Subject: Duke Energy Carolinas, LLC
Oconee Nuclear Station, Units 1, 2, and 3
Docket Numbers 50-269, 50-270, and 50-287,
Renewed Operating Licenses DPR-38, DPR-47, and DPR-55
Tornado Mitigation License Amendment Request - Response to Request for
Additional Information

Nuclear Regulatory Commission
Tornado Mitigation Licensing Amendment Request - Responses to RAI
June 24, 2010

Enclosure
Responses to RAI

Figure
RAI 2-15, Location of FRP Test Panels for Units 1, 2, and 3
(6 pages)

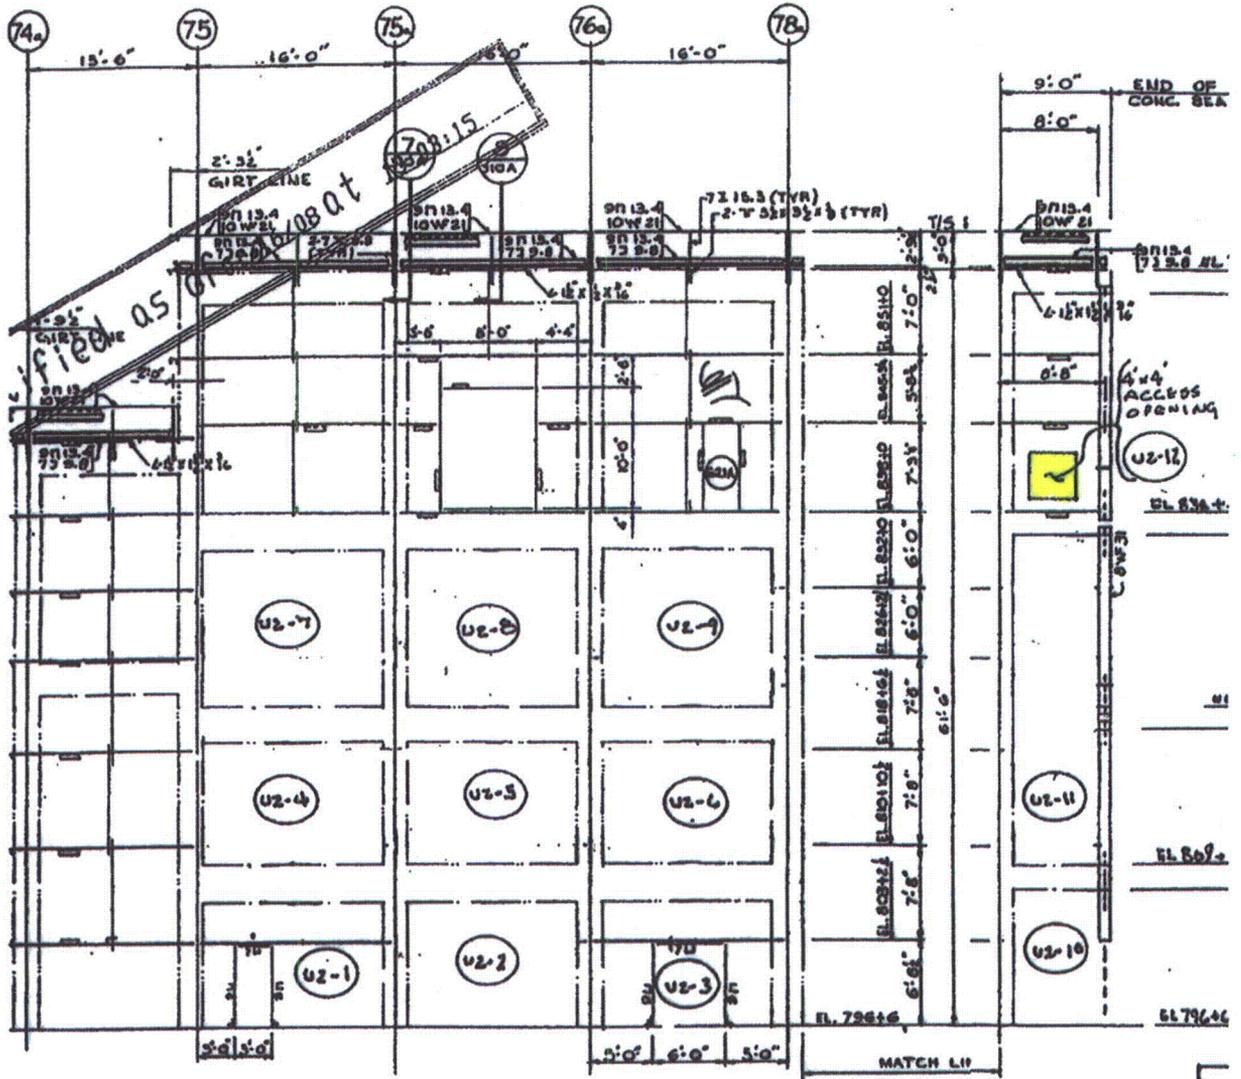
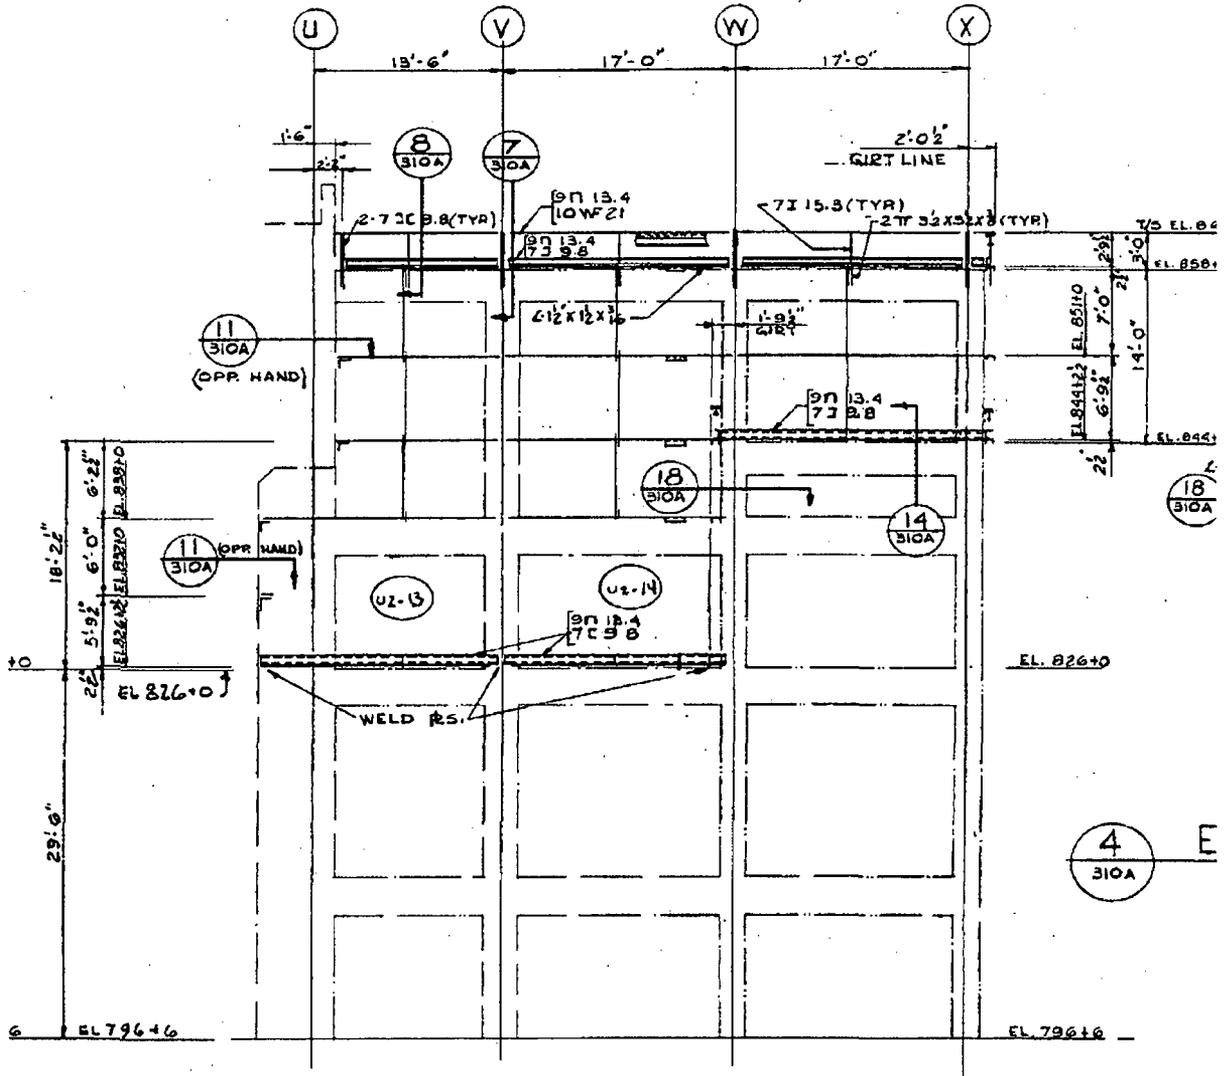
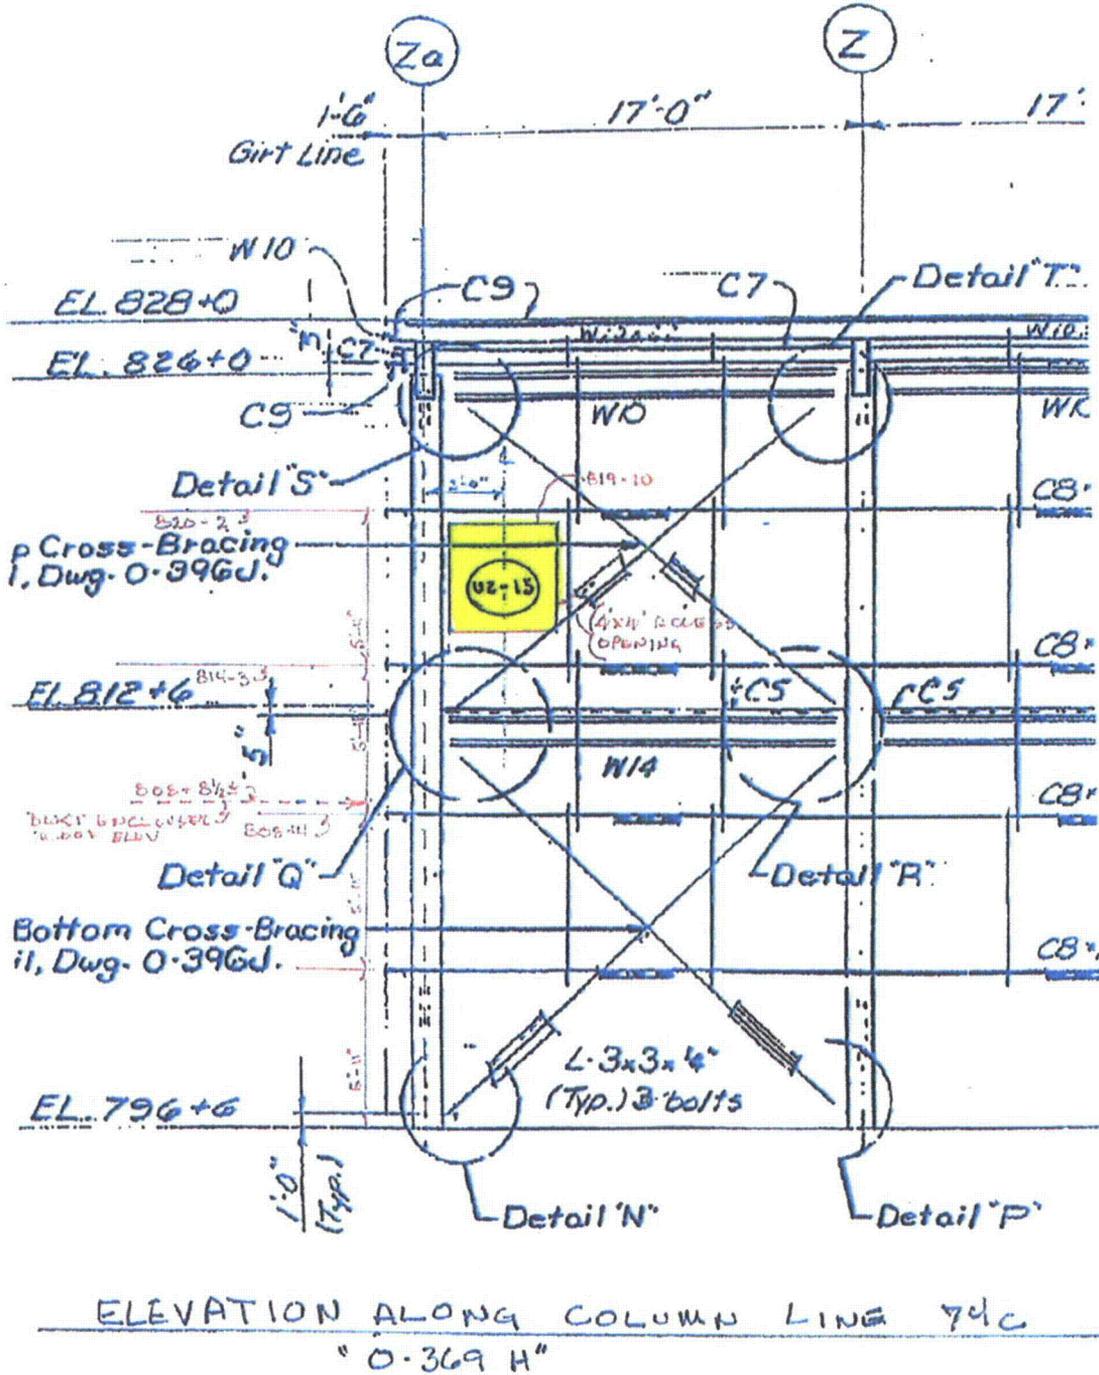
Page 4 of Enclosure 2 of the June 29, 2009, LAR states that as part of the long term surveillance program, visual inspections will be performed on selected portions of FRP strengthened brick walls and adjacent test walls. Please provide further clarification relative to the term "selected portions."

Page 4 of Enclosure 2 of the June 29, 2009, LAR states that the test walls will be more accessible for tension adhesion testing, implying that the test walls are not configured the same as the FRP modified walls (e.g., there is no siding to remove). Considering RAI 2-9 please provide further discussion to justify that the test walls are exposed to the same environmental conditions as the FRP modified walls.

Four (4) FRP test panels will be installed on Auxiliary Building masonry walls for in-service surveillance of the FRP system (i.e., visual inspections and tension adhesion testing (destructive examination)). Their locations are shown in Figure RAI 2-15, Sheets 1 through 6. FRP test panels will be installed in the same manner as the design applications. FRP test panels will be subject to the same environmental conditions as the design FRP-strengthened wall elements (i.e., located on a west-facing wall behind removable siding). In-service surveillance of the FRP system will be performed only on the FRP test panels, not on the design FRP-strengthened wall elements. Should this surveillance reveal any adverse condition, the design FRP-strengthened wall elements would be inspected and / or tested by removing the external structural siding; however, removal of this siding would present a degraded condition with respect to design-basis tornado wind loading and would be managed under Oconee Site Directive (SD) 3.2.16.

Four (4) FRP test panels will be installed on Auxiliary Building masonry walls for in-service surveillance of the FRP system. Their locations are shown in Figure RAI 2-15, Sheets 1 through 6. FRP test panels will be installed in the same manner as the design applications. FRP test panels will be subject to the same environmental conditions as the design FRP-strengthened wall elements (i.e., located on a west-facing wall behind removable siding). To facilitate in-service surveillance of the FRP test panels, small, readily removable portions of siding will be installed; however, no such access points will be provided for the design FRP-strengthened wall elements.
